Docket Item # 3  
BAR CASE # 2012-0073

BAR Meeting  
April 18, 2012

**ISSUE:** Waiver of HVAC Rooftop Screening Requirement

**LOCATION:** 711 Princess Street

**Figure 1. Plat of subject property showing location of HVAC units.**

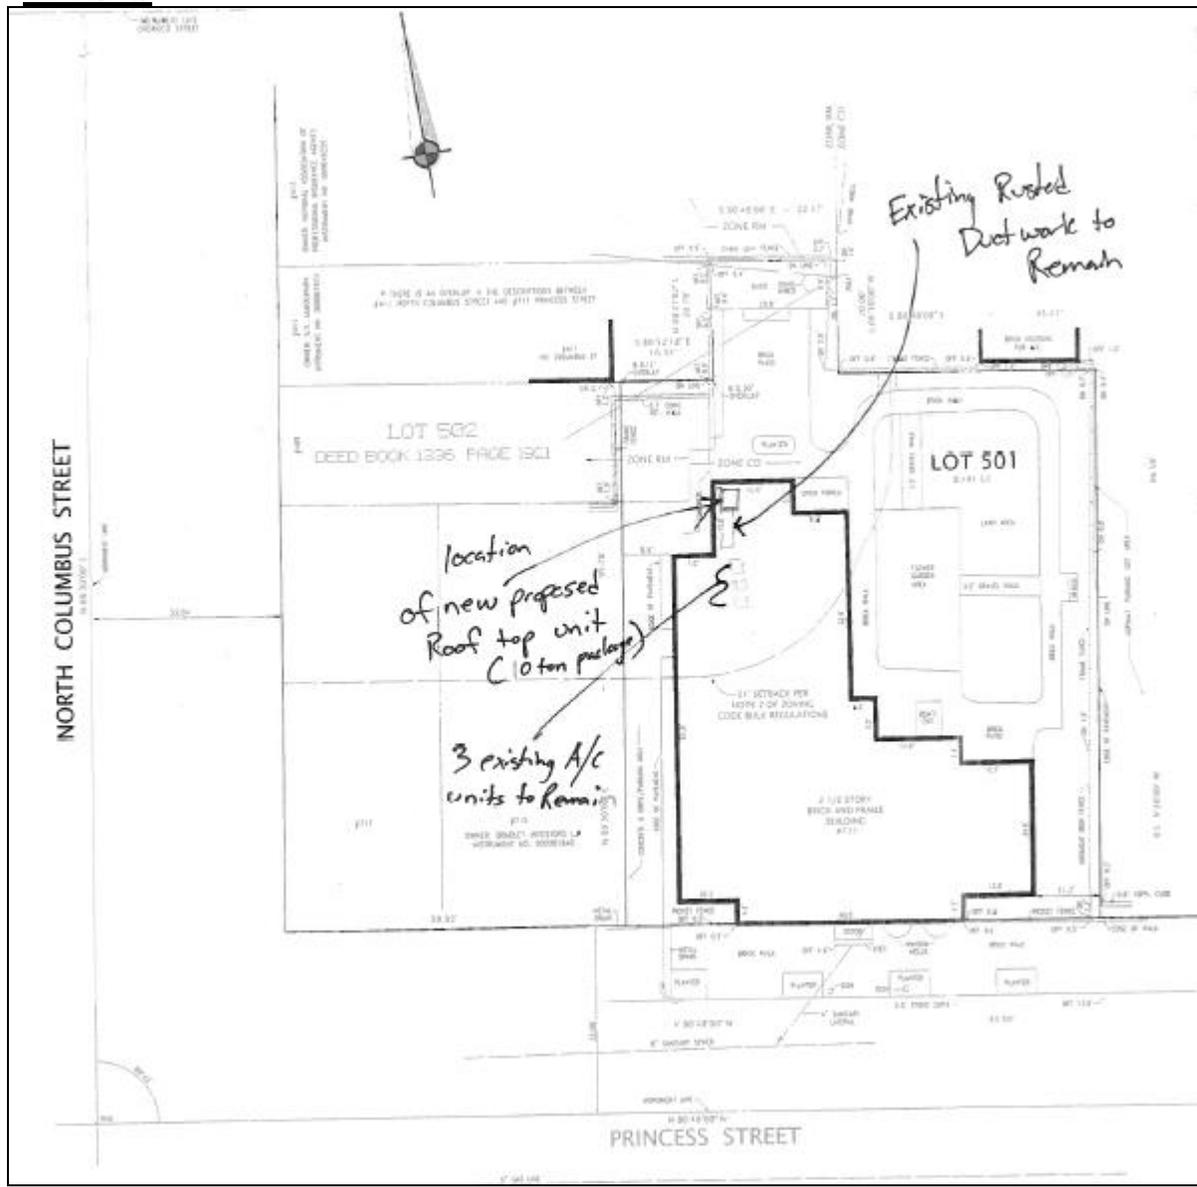
The applicant is requesting approval to install rooftop HVAC equipment on a one-story rear addition and a waiver of the rooftop HVAC screening requirement. The proposed unit replaces a package unit with sizeable exterior ductwork connecting to interior ductwork. The existing rusting ductwork will remain. The replacement unit will measure approximately 5.25 feet in depth, 9.6 feet in width and 2.5 feet in height, similar in size to the existing unit. The unit is plainly visible from both Princess and North Columbus streets.

Following archival research for this application, and discussion with the property owner, it is apparent that it is unlikely that the existing package unit was ever approved by the Board. The existing unit will be replaced in the same location as the existing and is located above a one-story element toward the rear of the west side. There are also several split system HVAC condenser units located on the same rooftop which are also visible. The property on which the house is located is relatively large and there are potential areas where units could be ground-mounted. However, moving the package unit and duct work as well as multiple HVAC

condenser units would be a sizeable project well beyond simple replacement and would likely require an extensive reconfiguration of duct work which may be more difficult to disguise than the proposed package unit itself.

The *Design Guidelines* note that “HVAC equipment should be located in a visually inconspicuous area of a building” and “rooftop HVAC equipment is generally discouraged on small scale structures and the front roofs of building because they create visual disruption of the historic streetscape and are difficult to screen effectively.” In many instances, the screening of HVAC rooftop equipment is more visually obtrusive than the unit itself. Although these units are plainly visible from two public streets, Staff notes that they are located toward the rear of the property and not overly obtrusive since they are on a one-story portion, rather than on the main roof. Therefore, a solid screen is not necessary and Staff believes that painting all the units and ductwork to match the adjacent wall and installing a simple open metal railing on the one-story section immediately in front of the units will serve as effective screening and unify this jumble of mechanical equipment while still allowing the necessary air circulation. If this application were for new units, Staff would recommend that they be located on the ground as there is substantial room on this property. Staff does find the rusted ductwork to be particularly unsightly and that it draws one’s attention away from the historic building and recommends that it either be painted or replaced as part of the project.

Staff recommends denial of the waiver of rooftop screening and approval to replace the package unit with the condition that the new unit and associated ductwork, as well as the existing HVAC condenser units, be painted to match the adjacent wall and that a simple metal railing be installed on the rooftop to serve as screening, with final approval by Staff.
